**PLANNED UNIT DEVELOPMENT
& SUBDIVISION STAFF REPORT****Date: September 21, 2006****DEVELOPMENT NAME**

Saunders Subdivision

Planned Unit Development approval to allow two office/warehouse buildings on a single building site, and Subdivision approval to create one lot.

SITE PLAN

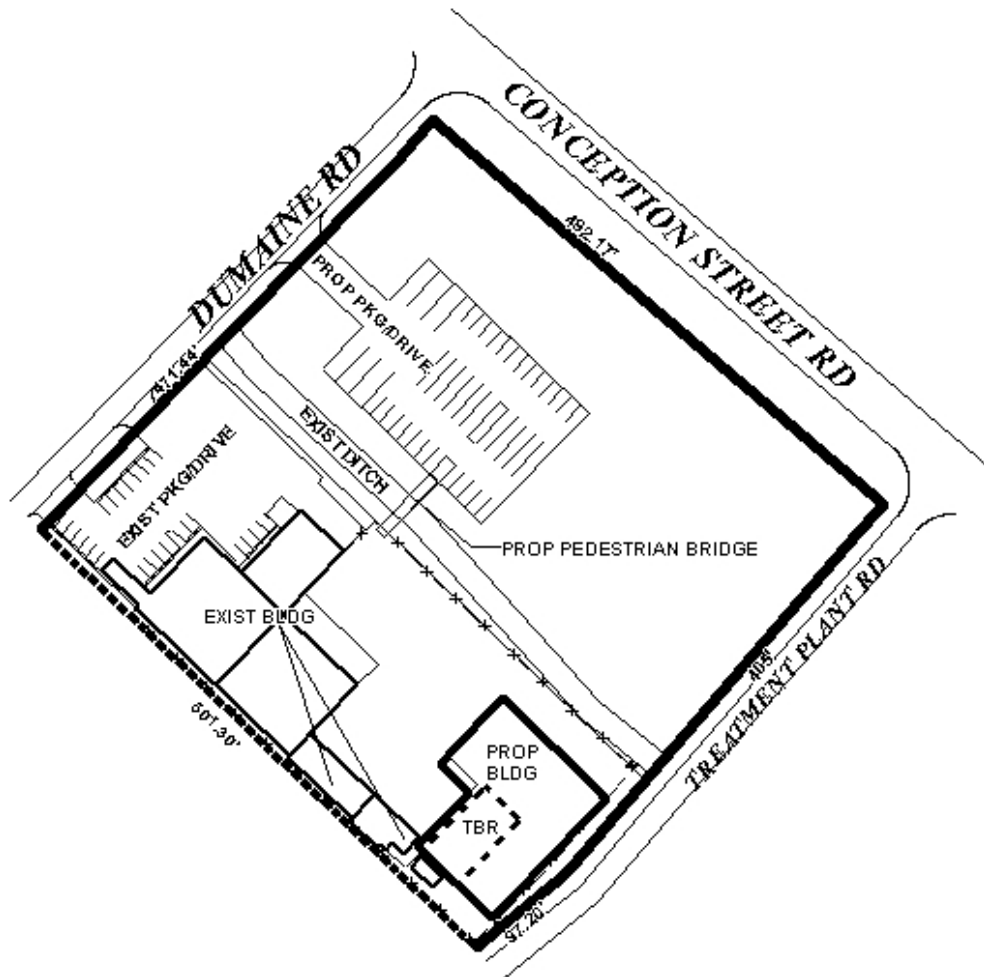
Access management is a concern due to Conception Street Road's status as a major street. The applicant has not proposed any direct access to Conception Street Road, and instead it appears that all access will be via Dumaine Road, with a total of three curb-cuts – two existing and one new. The site should be limited to a total of three curb-cuts, with the size, design and location to be approved by Traffic Engineering and conform to AASHTO standards.

The property lines at the street intersection corners should be revised to comply with the requirements of Section V.D.6. of the Subdivision Regulations.

The 25-foot minimum building setback line, required in Section V.D.9. of the Subdivision Regulations, is not shown on the subdivision plat or site plan. The required minimum building setback line would be required from all street frontages, thus the proposed new building would not comply with the 25-foot required setback. However, a reduction of the setback requirement along Treatment Plant Road to 10 feet may be appropriate, per the request, and the fact that a site located on the South side of Treatment Plant Road has established a reduced setback as precedence along the road. The 25-foot setback is still required along the Conception Street Road and Dumaine Road frontages.

The site is partially located in the 100-year floodplain associated with a branch of Three Mile Creek. The flood information is not graphically depicted on the subdivision plat or the site plan, thus the drawings should be revised to reflect this information per the comments provided by the Engineering Department.

The site plan depicts existing and proposed parking areas. One of the existing parking spaces appears to be partially located in the right-of-way for Dumaine Road, which is not permitted. The proposed parking area appears to depict parking for personal vehicles as well as commercial trucks. It appears that the maneuvering space within the proposed parking area may not be adequate for personal vehicles or commercial trucks. Therefore, the site plan should be revised to ensure that all required parking occurs within the subdivision boundaries, and that adequate maneuvering area is provided in the new parking lot.

It appears that 52 parking spaces for personal vehicles will be provided, which appears to be adequate (additional parking for personal vehicles may have been provided, however it appears that a line is missing in the new parking area to divide a row of parking). The applicant states that he anticipates a total of 5 warehouse personnel, thus the site will exceed the minimum required parking.

There is no indication on the site plan as to the proposed location of any dumpster or other waste storage facility. The location of the storage area for the dumpster must be indicated on the site plan, and the location and required screening must comply Section 64-4.D.9. of the Zoning Ordinance, as well as with all other applicable regulations.

Finally, the site plan and plat are drawn to scale, yet no scale or North arrow are depicted on either drawing.

1) dedication of sufficient right-of-way to provide 50 feet, as measured from the centerline of Conception Street Road; 2) placement of a note on the site plan and plat stating that the site is limited to a total of three curb-cuts, with the size, design and location to be approved by Traffic Engineering and conform to AASHTO standards; 3) revision of the site plan and plat to comply with Section V.D.6. of the Subdivision Regulations (intersection corners); 4) revision of the site plan and plat to reflect Engineering comments (*Show delineation of the AE and other flood zones on the final plat. The minimum finished floor elevation must be shown on each lot affected by the AE flood zone. If the ditch shown conveys public water, a drainage easement will be required from the top-of-bank to top-of-bank plus 15 feet on one side to allow for maintenance vehicles. Must comply with all stormwater and flood control ordinances. Any work performed in the right of way will require a right of way permit. The applicant is responsible for verifying if the site contains wetlands. The site can be checked against the National Wetlands Inventory on the COM web site Environmental Viewer. If the site is included on the NWI, it is the applicant's responsibility to confirm or deny the existence of regulatory wetlands.*); 5) revision of the site plan to show all parking spaces as being provided within the subdivision boundaries, and revision of the site plan to show maneuvering and aisle areas in the new parking lot that comply with AASHTO standards; 6) revision of the site plan and plat to depict the required 25-foot minimum building setback line along Dumaine and Conception Street Roads, and a 10-foot minimum building setback along Treatment Plant Road; 7) revision of the site plan to depict compliance with the tree and landscaping requirements of the Zoning Ordinance; 8) depiction of any dumpster locations on the site plan; 9) revision of the site plan and plat to show a graphic scale and North arrow; 10) provision of a revised site plan to the Planning Section of Urban Development prior to the signing and recording of the final plat; 11) completion of the Subdivision process; and 12) full compliance with all other municipal codes and ordinances.

Subdivision: With a waiver of Section V.B.14. of the Subdivision Regulations regarding the right-of-way widths for Dumaine and Treatment Plant Roads, this application is recommended for Tentative Approval, subject to the following conditions: 1) dedication of sufficient right-of-way to provide 50 feet, as measured from the centerline of Conception Street Road; 2) placement of a note on the site plan and plat stating that the site is limited to a total of three curb-cuts, with the size, design and location to be approved by Traffic Engineering and conform to AASHTO standards; 3) revision of the site plan and plat to comply with Section V.D.6. of the Subdivision Regulations; 4) revision of the site plan and plat to reflect Engineering comments (*Show delineation of the AE and other flood zones on the final plat. The minimum finished floor elevation must be shown on each lot affected by the AE flood zone. If the ditch shown conveys*
